**To:** Planning Commissioners  
**From:** Amy Steffens, AICP  
Planning and Zoning Director  
**Date:** May 31, 2023

**Project address and Description:** **Site Plan Review (SPA 23-0001)** for the construction of a 27,461 multi-tenant commercial building, with associated parking and site improvements. The applicant is requesting waivers to the landscaping standards. Site location 7749 E M-36; TID 15-25-200-068.

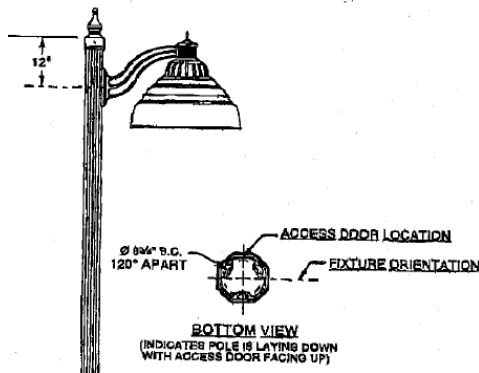
The lighting plan provided is adequate to determine the conformance to the zoning ordinance requirements. However, staff would suggest that the exterior light style does not match the Village Center lighting style that has been installed in various locations throughout the Village Center, most recently at the senior living facility on the south side of M-36 (below).

**Staff Suggestion Condition:** Applicant shall propose an exterior light that is similar to the suggested Village Center lighting and shall re-submit a photometric plan prior to issuance of a land use permit that is specific to the approved lighting style.

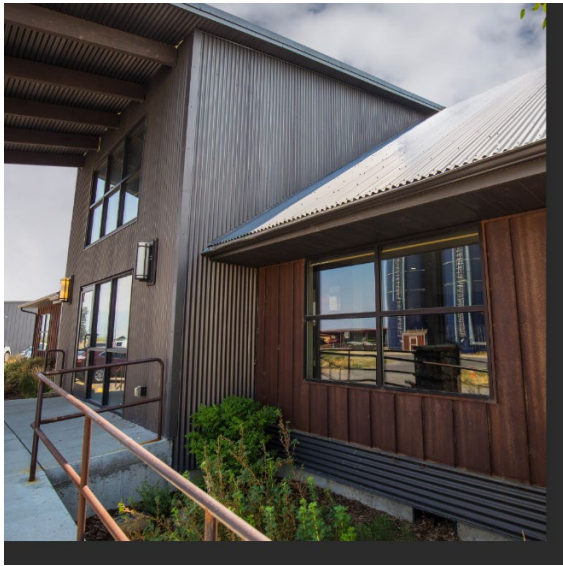
Section 36-73(7) specifies that “For any side of a principal building facing a public or private street, at least 50 percent of the facade shall be constructed of, or covered with, the following materials: brick; fluted or scored concrete block; cut stone, vinyl siding; vinyl siding; glass; or other materials similar to the above as determined by the Planning Commission.” The metal siding would need to be approved by the Commission as an acceptable substitute to the noted materials.

Additionally, building walls over 100 feet in length shall be broken up with a combination of the following: varying building lines, windows, architectural accents, and trees. The only windows on the 292-foot long east elevation are the windows on the tenant space entry doors.

The proposed elevations are uninspired and wholly inappropriate for a commercial structure along a gateway into Hamburg Township that is zoned Village Center. There are multiple ways to add interest to a metal-sided rectangular building. Height and depth articulations, additional windows, and a mix of exterior finishes would break up the expansive east elevation and add aesthetic interest to the south elevation. Staff offers the images below as examples of architectural details that could be used on the proposed building. The Commission should also consider requiring additional finishes on the south and north elevations.

LA1.1

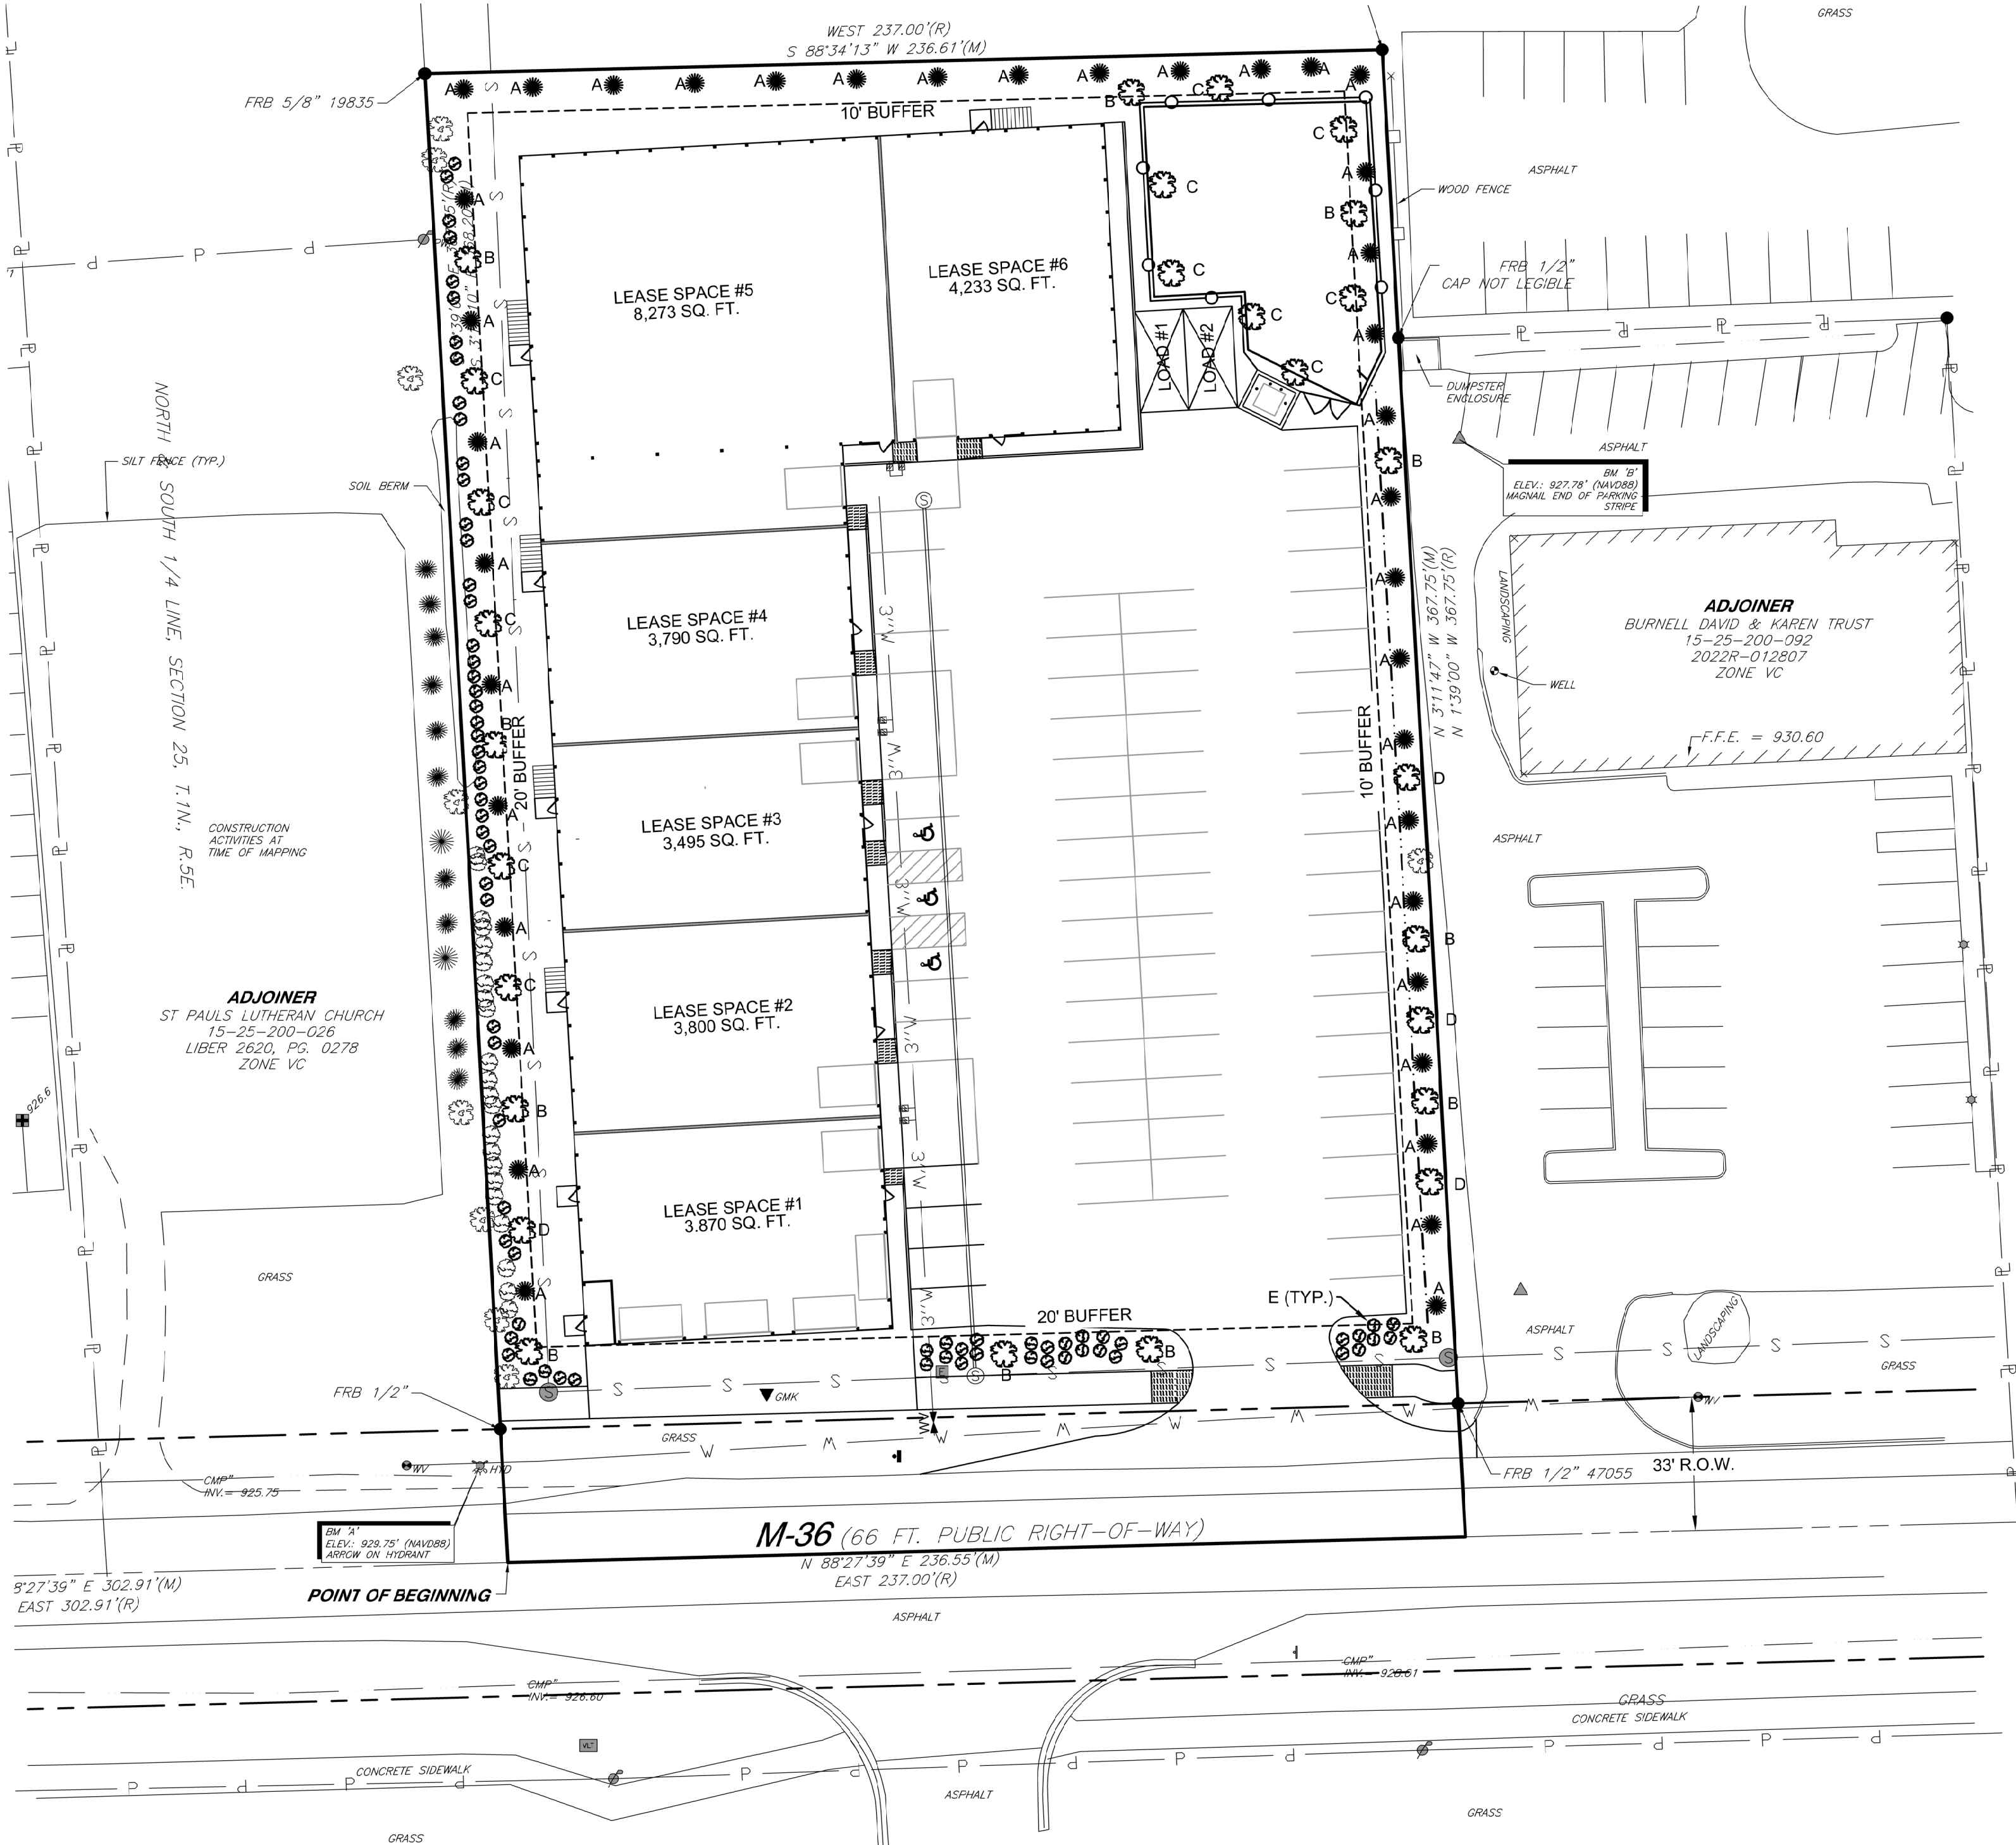
**Staff analysis:** Existing plant material to be saved is not noted on the site plan; tree protection details are included in the site plan.

**Staff analysis:** The proposed row of boxwoods would screen the parking lot from M-36, so long as the height is maintained at three feet, but additional boxwoods should be planted within the east setback to further screen parking from M-36.

**Staff analysis:** One additional tree should be planted along the M-36 frontage in order to comply with this requirement.

**Staff suggested condition:** Tree preservation details shall be delineated on the final site plan.
